Addendum No. 2

Subject: Joseph W. Catharine Elementary School
2022 Classroom Modernization
SDP Contract Nos. 2022-008-G, 2022-008-P, 2022-008-E

Location: Joseph W. Catharine Elementary & Annex Schools
6600 Chester Avenue & 6900 Greenway Avenue
Philadelphia PA 19142

This Addendum No. 2, dated FEBRUARY 18, 2022, shall modify and become part of the proposed Contract Documents of the work of this project. Any items not mentioned herein, or affected by, shall be performed strictly in accordance with the original Contract Documents, unless modified by prior addenda.

DRAWING NO.
E200-B

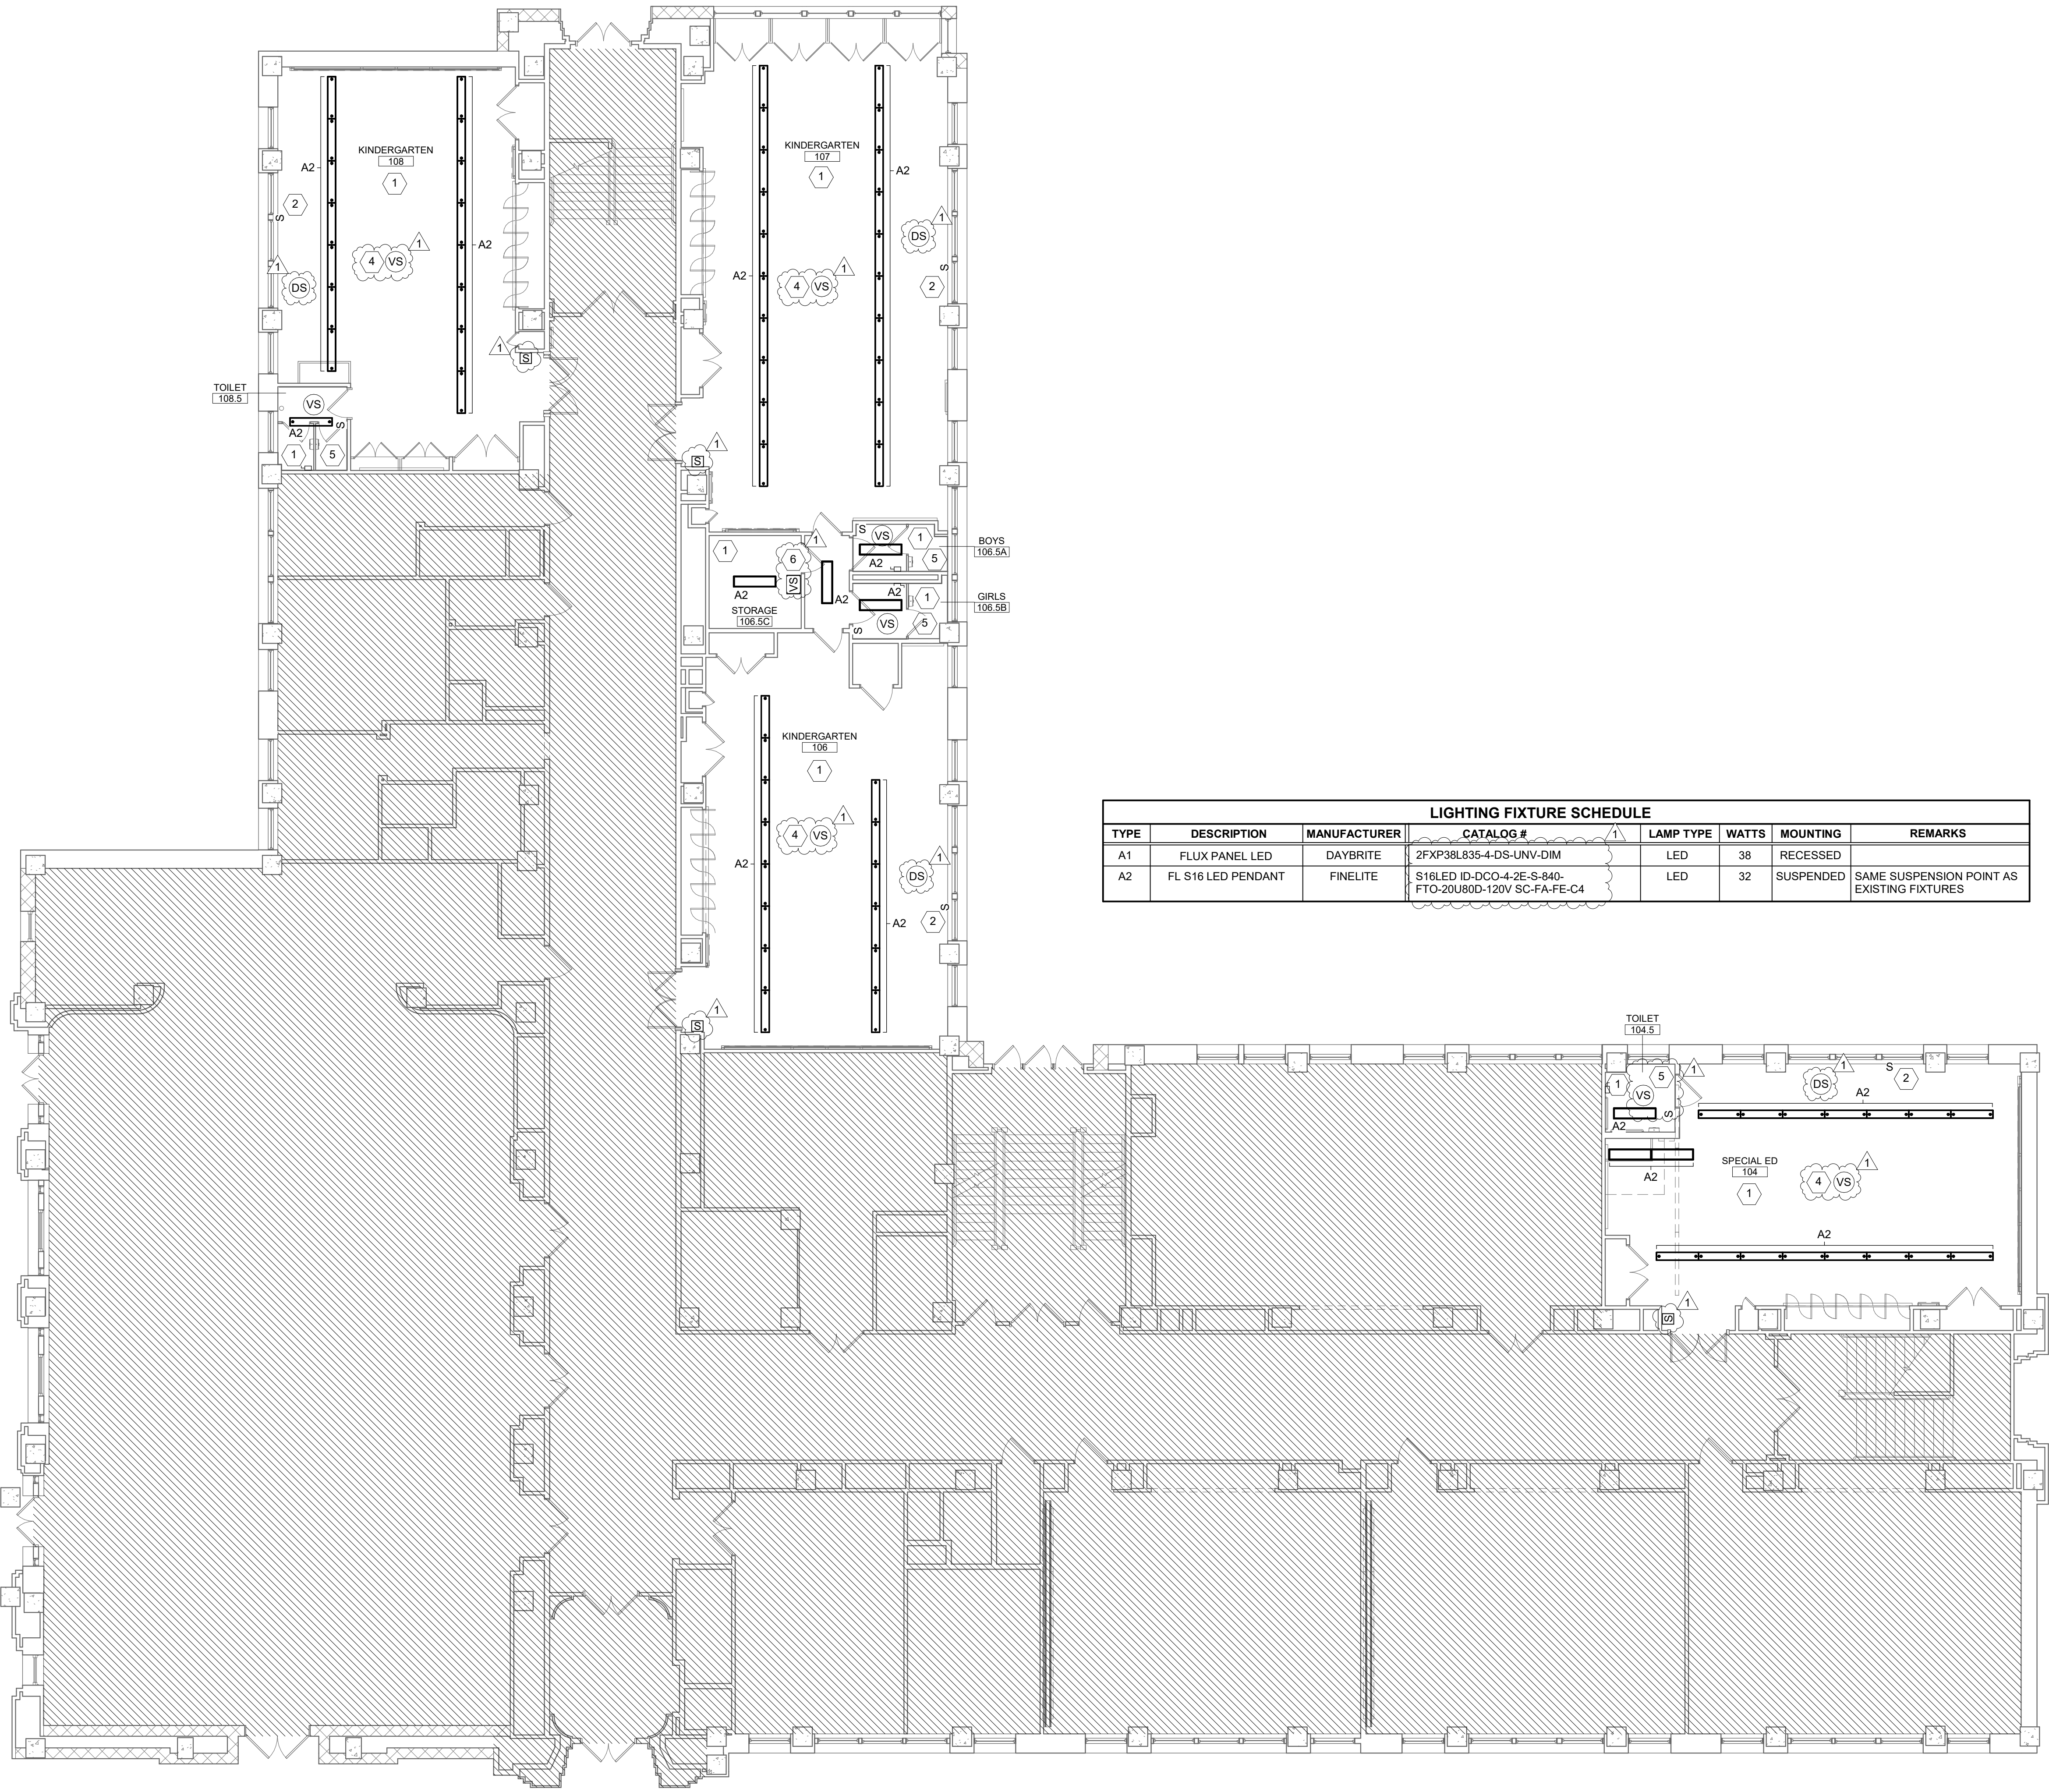
11. **Question:** Drawings E200-A, E200-B, E201, E202 sheet new work keynote #1 calls for dimming lighting controls in the classrooms but the note has very little detail on design requirements. The floor plans

show nothing in terms of design for the lighting controls (control layout, zoning, basis of design part numbers etc.). The floor plans conflict with keynote #1 and show single pole switches which do not dim. Why was a design not provided with basis of design control part numbers like all other typical SDP projects?

Response: Refer to revised E200 series and E501 drawings for wiring and controls information.

DRAWING NO.
E201

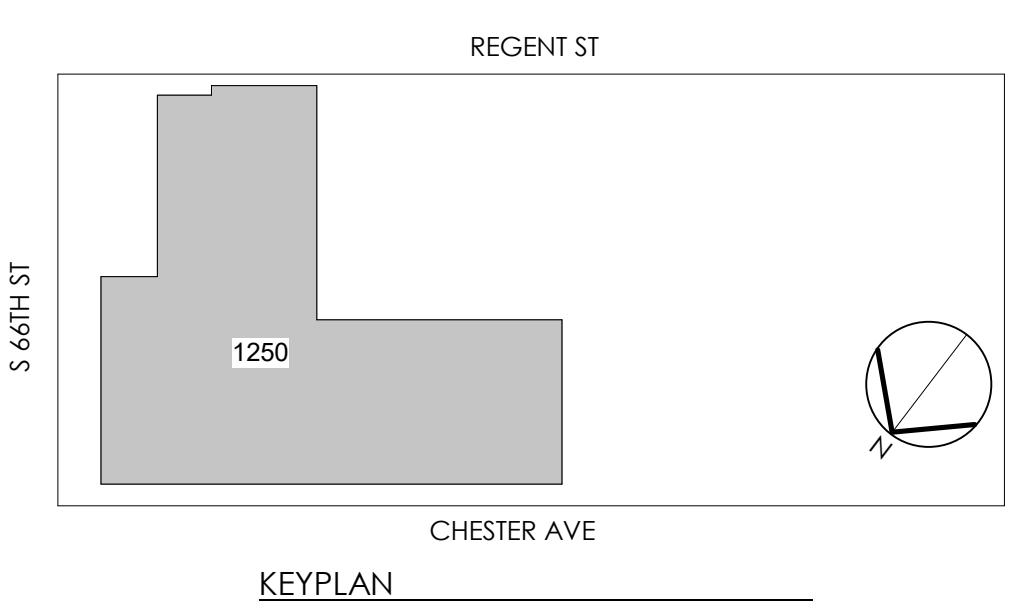
14. **Question:** Drawing E202 specifies type A1 fixture on the fixture schedule. The lumen selection per the fixture schedule catalog number is "384L" which is not possible per the cut sheet and appears to be a typo. Please clarify lumen section.

Response: Refer to lighting fixture schedule on revised E201 attached.

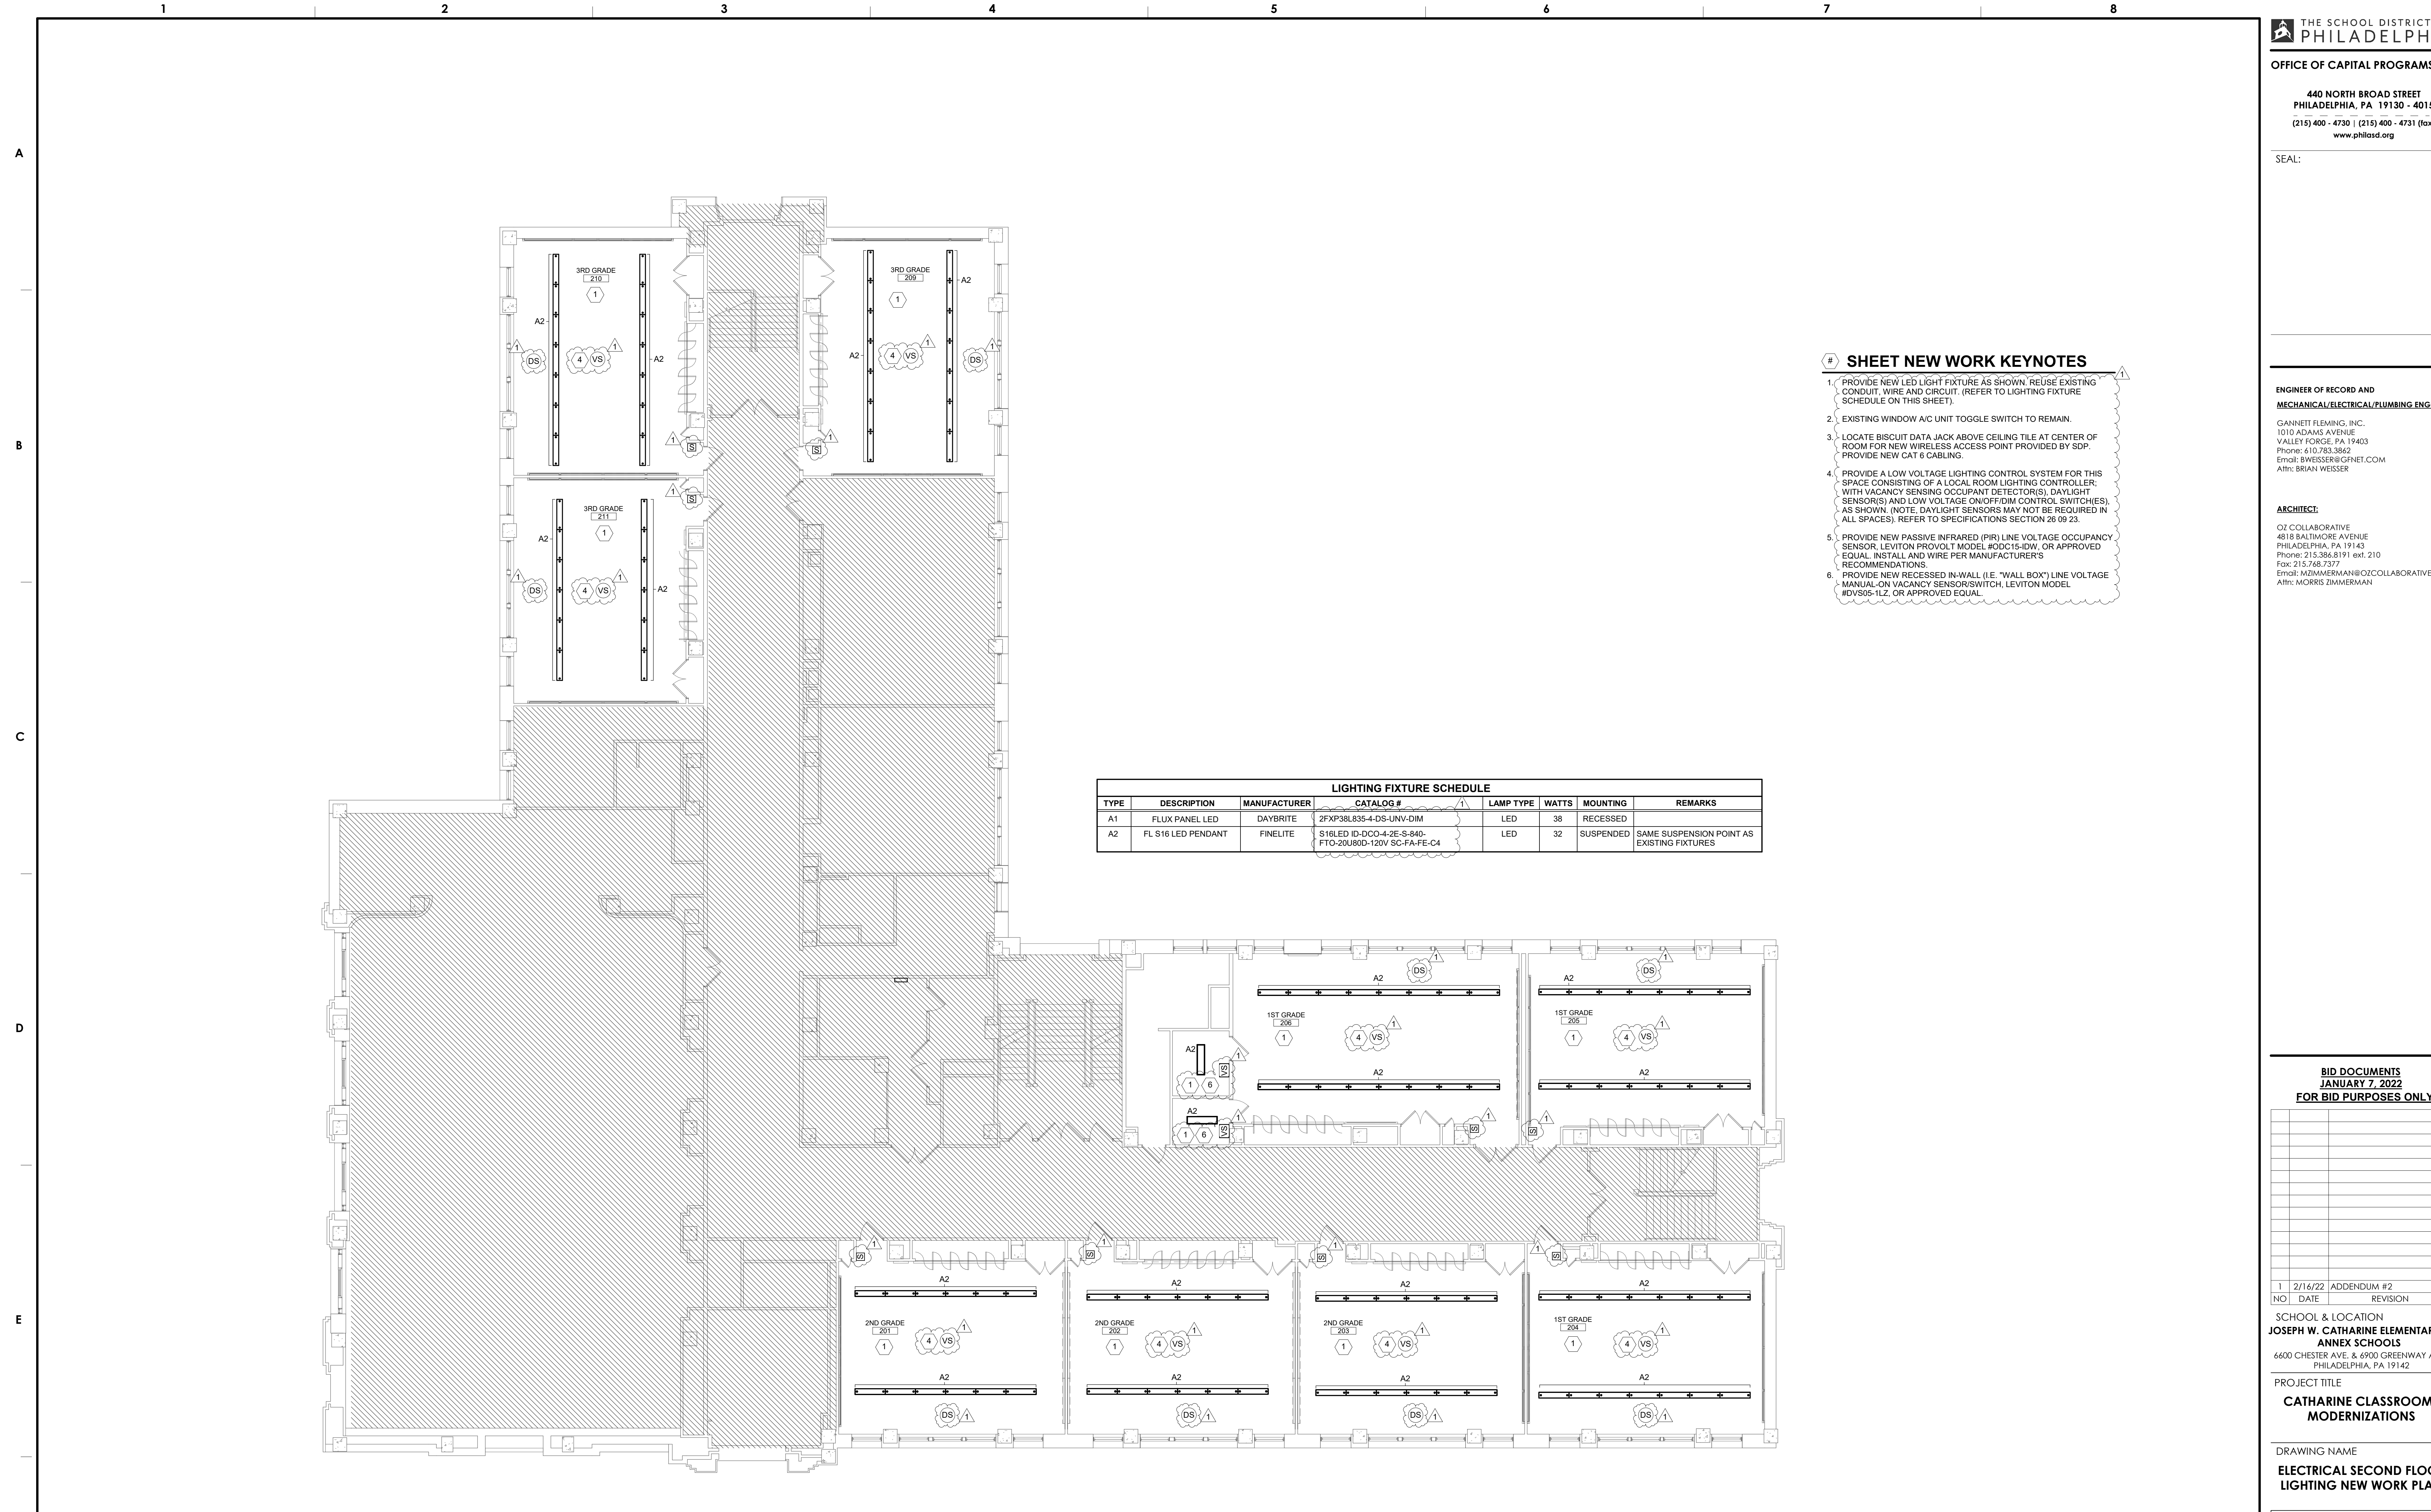
2. **Question:** Where is the MDP? Not shown on any floor plans.

Response: MDP is located in the meter room (basement), see attached basement plan.
